**REMARKS**

At the time the present Office Action was mailed (November 23, 2005), claims 26-38 and 42-90 were pending in the above-captioned application, with claims 42-48 and 84-90 withdrawn from consideration. In this response, claims 42-48 and 62-90 have been cancelled. Accordingly, claims 26-38 and 49-61 are currently pending.

**AMENDMENTS TO THE DRAWINGS**

Fig. 1

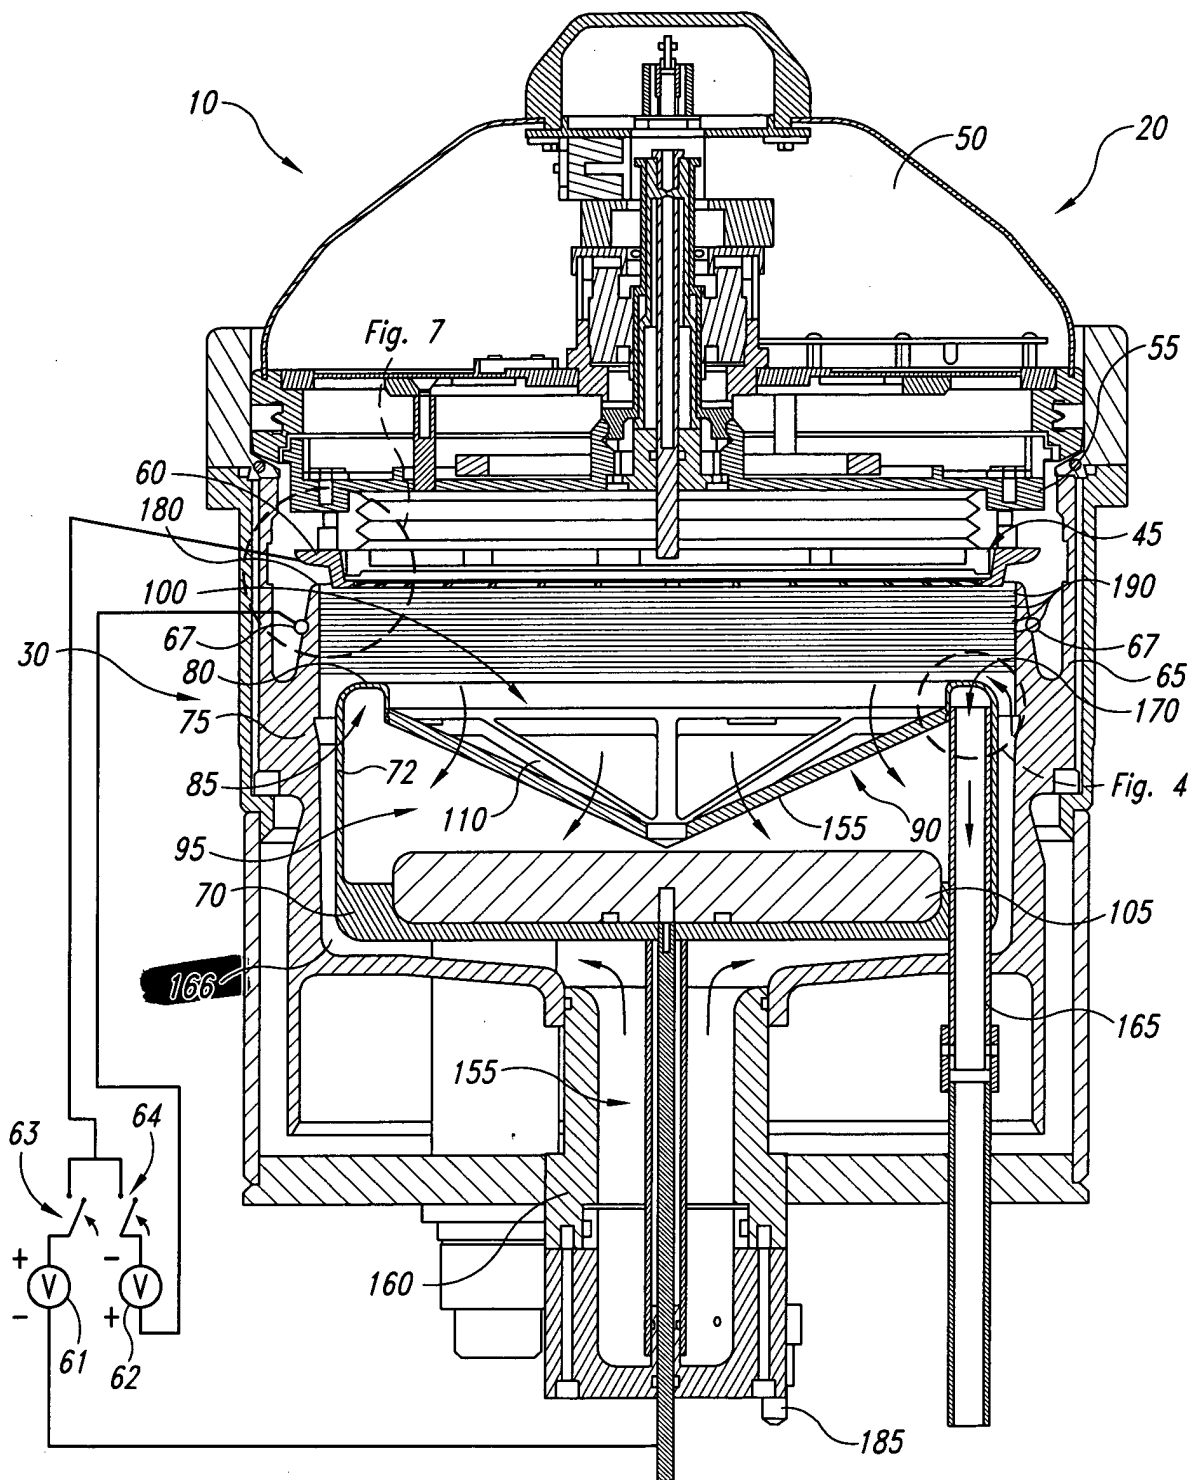
Figure 1 was objected to because the reference character "165" was used to designate both the space formed between the electrode housing assembly and the process cup assembly, and a fluid outlet tube. Figure 1 has been corrected to change the reference character designating the space between the electrode housing assembly and the process cup assembly to be "166," as reflected in the corrected drawing sheet. The specification at page 15, last paragraph has been amended in accordance with the foregoing drawing change.

The attached sheets of drawings (formalized version) include changes to Figure 1, which has been amended to change one of the two occurrences of reference numeral "165" to "166."
